PROJECT NAME: <b>OXFORD ST. SHELTER          BATHROOM &amp; LOCKER CONTAINER</b>	
PORTLAND MAINE SHEET NAME: <b>LOCKER FLOOR PLAN</b>	
PROJECT NO. 17289 DRAWING NO. 17289A	REVISIONS NO. DATE DESCRIPTION
CLIENT: ICE DESIGNER: DFW CHECKER: ICE APPROVED: ICE PLAN DATE: JAN. 09, 2018 CLIENT # OWNER: SPACE SOLUTIONS 35 BAKER BLVD BREWER, MAINE 04412	DATE ISSUED: JAN. 09, 2018 SCALE: MAIN DATE: JAN. 09, 2018
<b>Plymouth Engineering, Inc.</b> P.O. Box 46 30 Lower Detroit Road Plymouth, Maine 04999 Tel: (207) 257-2071 Fax: (207) 257-2130 info@plymouthengineering.com www.plymouthengineering.com	
SHEET 3 OF 3 <b>A3</b>

LOCKER CONTAINER PLAN (3)  
SCALE: 1/2" = 1'-0"

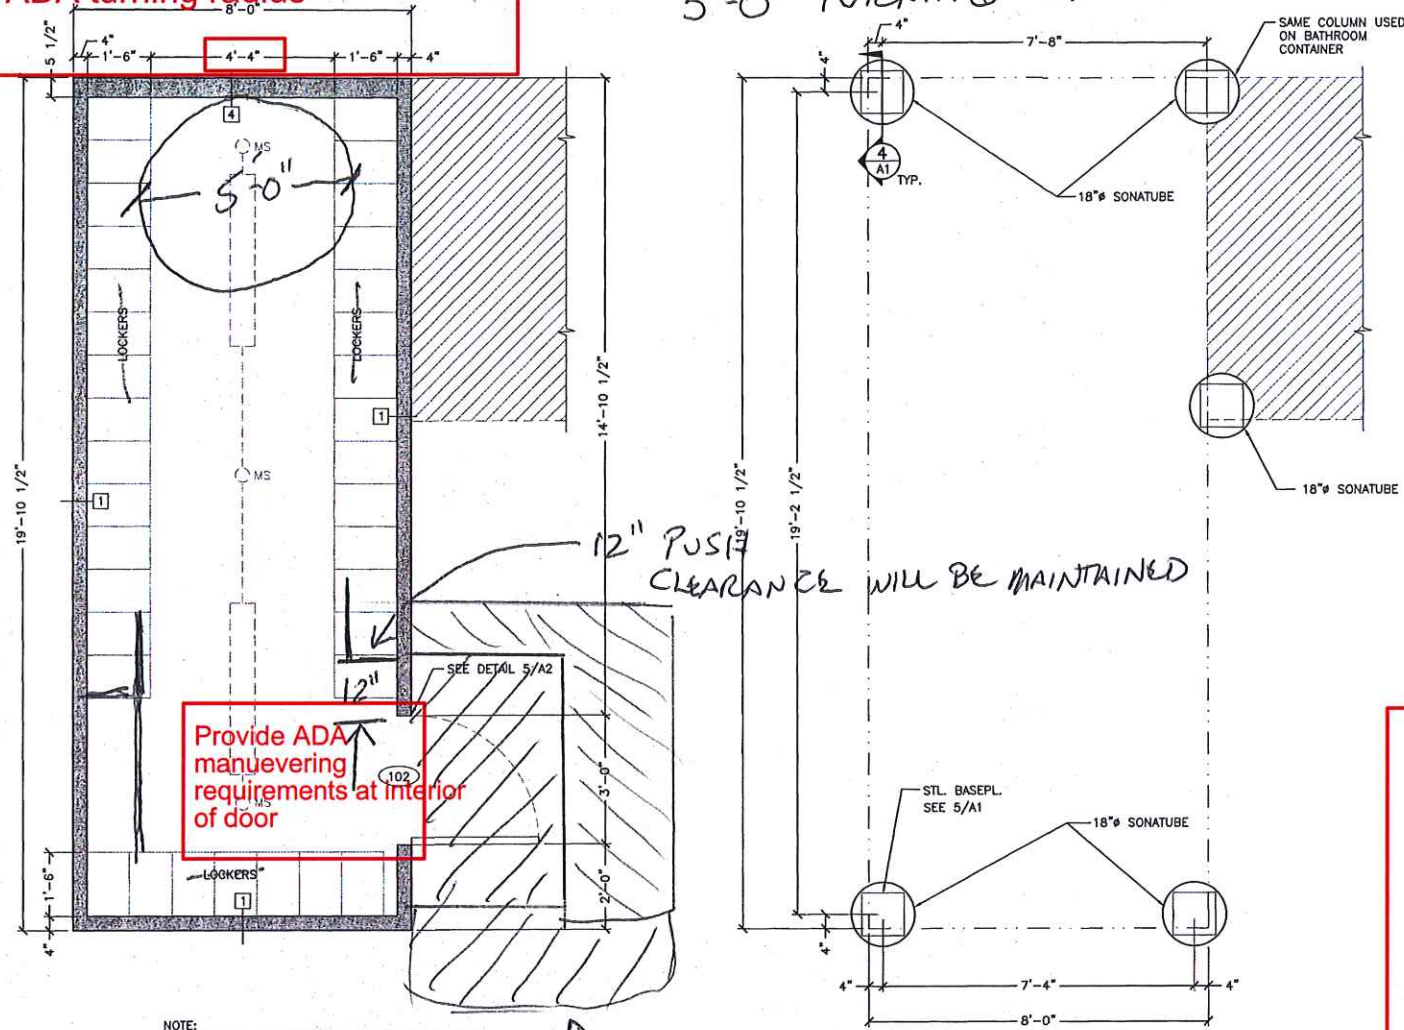
The width does not allow for a 5' ADA turning radius

Please provide a plan view and elevation of the ramp & landing with all required ADA elements including maneuvering clearances, dimensions, railings, edge protection, slope etc.
